TECHNICAL NOTE				VELOCITY			
Page No.	16 of 17	Project No.	24-243	Document No.	TN01	Date	OCTOBER 2024

3.1.1 This TN has been prepared by VTP on behalf of APC for the purposes of evaluating a TA and FTP, submitted in support of an outline planning application (Reference: A/154/24/OUT) for a development proposal comprising of 190 residential units (Use Class C3) and a 600 sq.m community building (Use Class E(d, e) or F2(b)), together with the provision of open space, landscaping and associated infrastructure on land west of Bewley Road in Angmering, West Sussex.

**Figure 2-9: View of the A280/A27/Titnore Lane Roundabout Junction (South)**

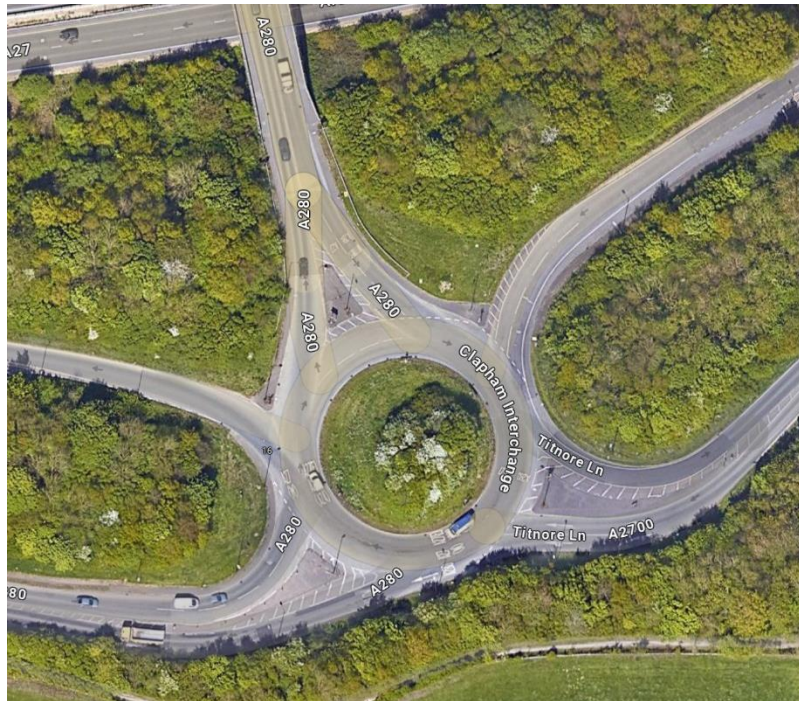
- 2.6.37 The geometry inputted into the junction model and used as the basis for the capacity assessment are generally reasonable and are reflective of the physical geometry of the junction.

- 2.6.38 During the day of the observation, lanes along the approaches of A280 (south-west) and Titmore Lane were coned out. Both arms had long queues, however as these were not reflective of typical conditions it is not known whether these are representative of a typical peak hour.

- 2.6.39 As with the northern roundabout it is recommended that the turning counts at arms with multiple lane approaches are reviewed, and where there is anticipated to be unequal lane usage adjustments should be made to the arms to reflect the on-site conditions.

- 2.6.40 A one-hour traffic flow profile type has used for the analysis. This type of profile is considered robust, as a higher proportion of traffic arrives in the middle of the hour, representing a peak within the hour.
